9A Fire Hazards Analysis

The information in this appendix of the reference ABWR DCD, including all subsections, tables, and figures, as modified by the STP Nuclear Operating Company Application to Amend the Design Certification rule for the U.S. Advanced Boiling Water Reactor (ABWR), "ABWR STP Aircraft Impact Assessment (AIA) Amendment Revision 3," dated September 23, 2010 is incorporated by reference with the following departures and supplement to 9A.1 Introduction. Additionally, the Fire Hazards Analysis for the Turbine Building in Section 9A.4.3 is replaced in its entirety.

Figure 9A.5-2 Typical Electrical Equipment Connection Block Diagrams of Special Cases

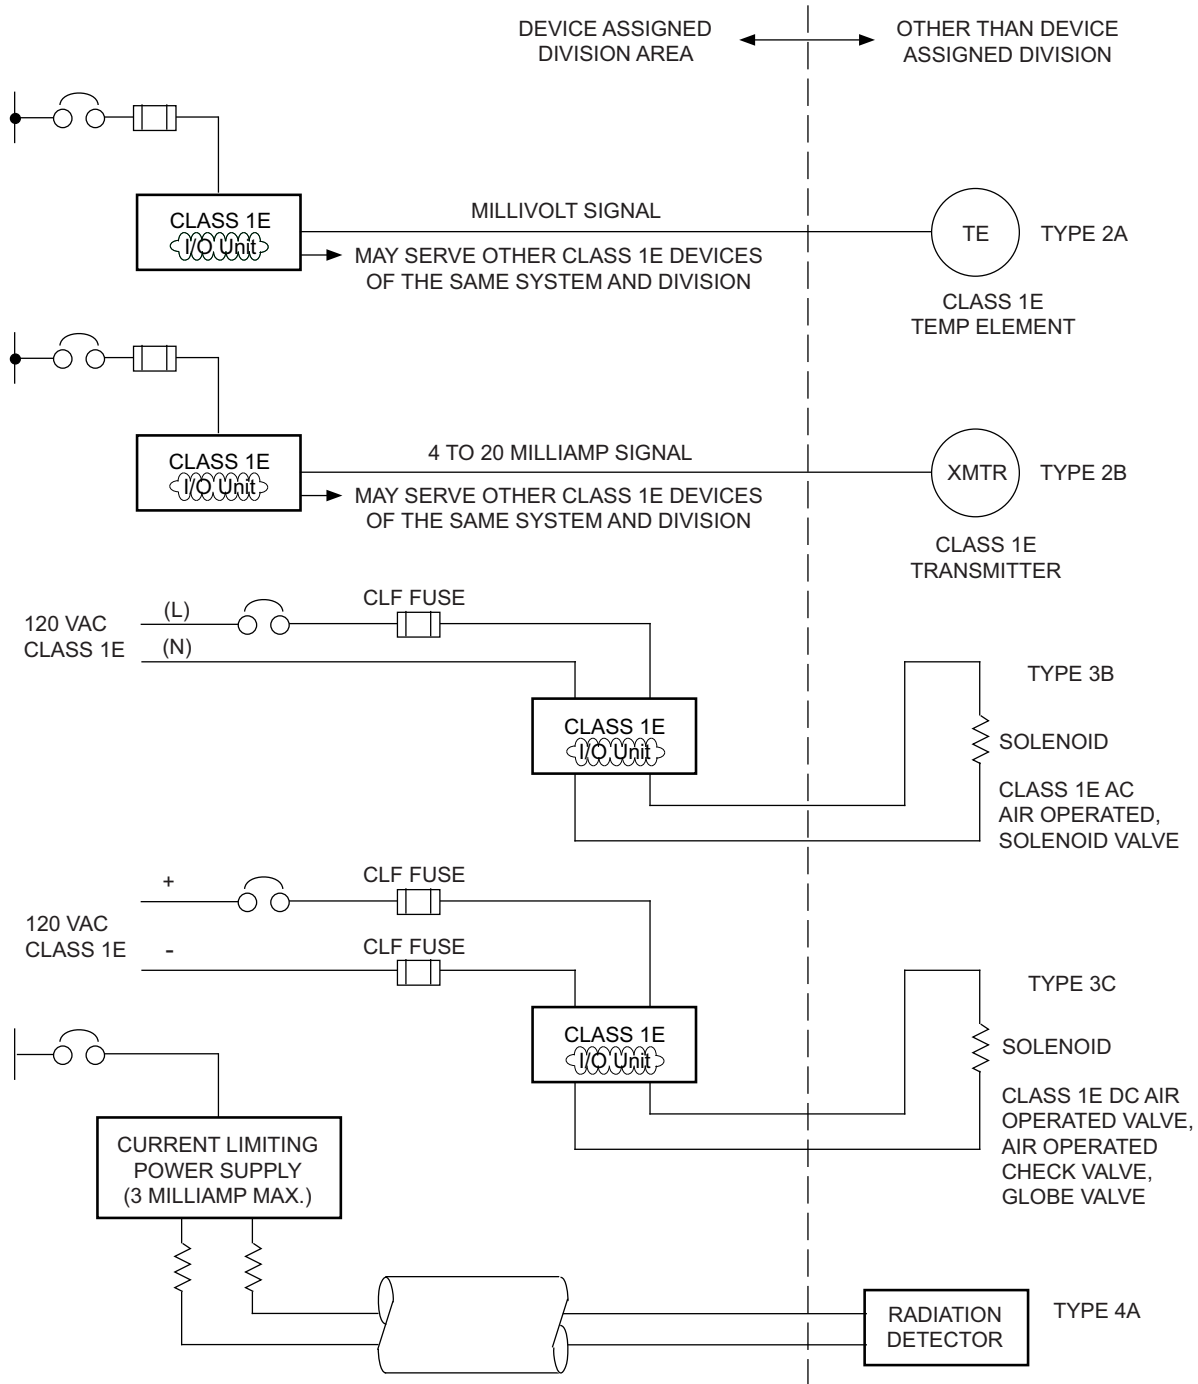
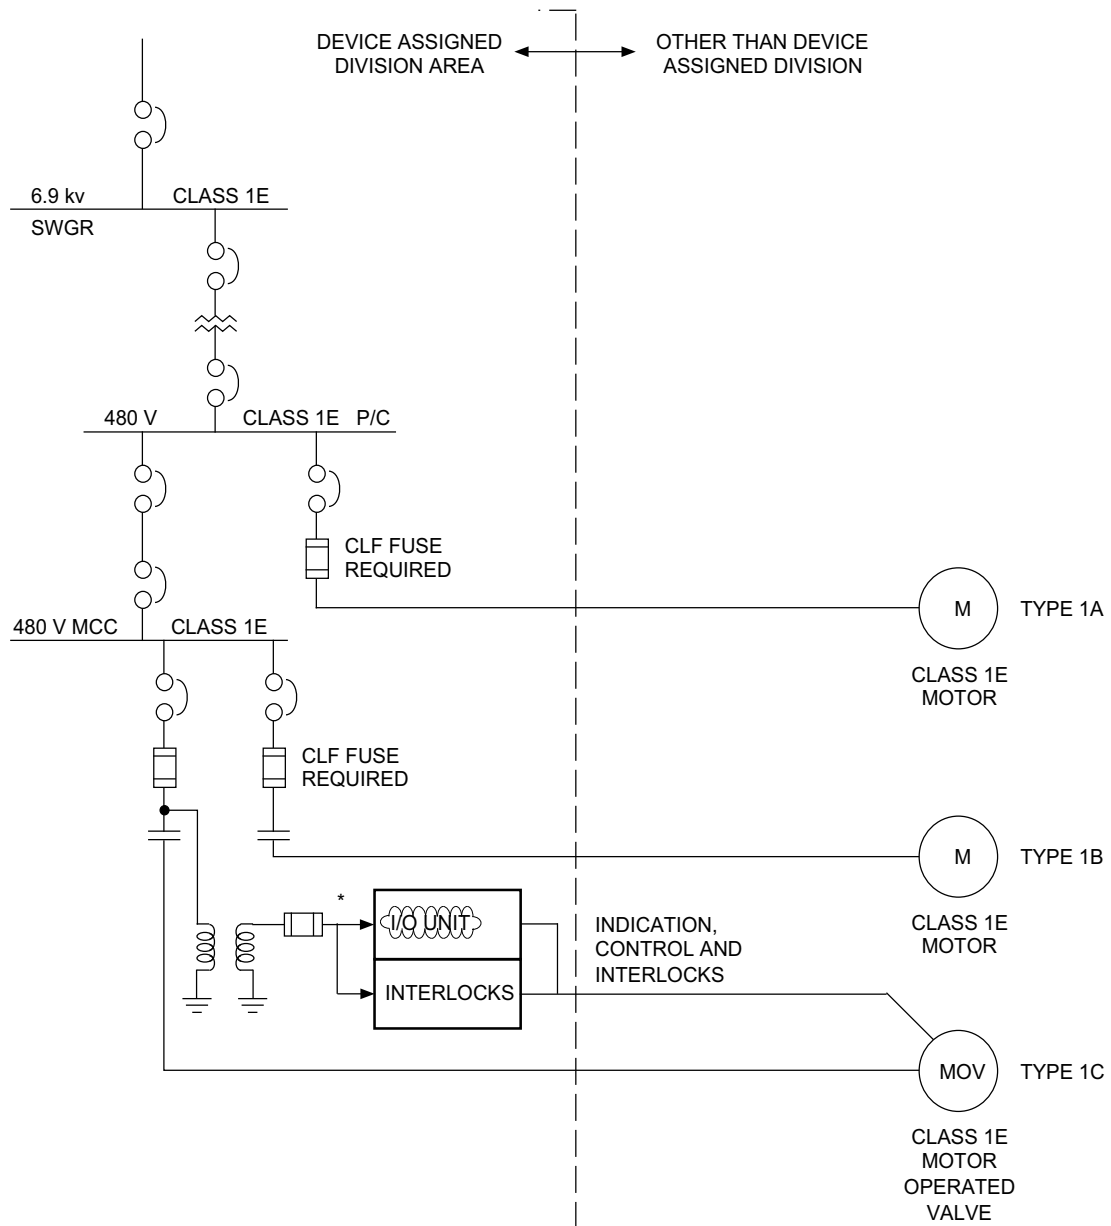
STD DEP T1 3.4-1 (Figure 9A.5-2)

STD DEP T1 3.4-1

The power for operating DC solenoid valves is supplied from the DC distribution system to the ~~demultiplexer~~ I/O unit for the valve. Both the supply and return for the DC are fused ~~at the multiplexer~~ so that faults are isolated and do not propagate back up into the portions of the DC system common with other systems.

* IT IS A REQUIREMENT THAT THE INDICATION, CONTROL AND INTERLOCK POWER FOR THIS DIVISIONAL CROSS-OVER TYPE BE FROM A CONTROL POWER TRANSFORMER IN THE CUBICLE SUPPLYING POWER TO THE MOV.
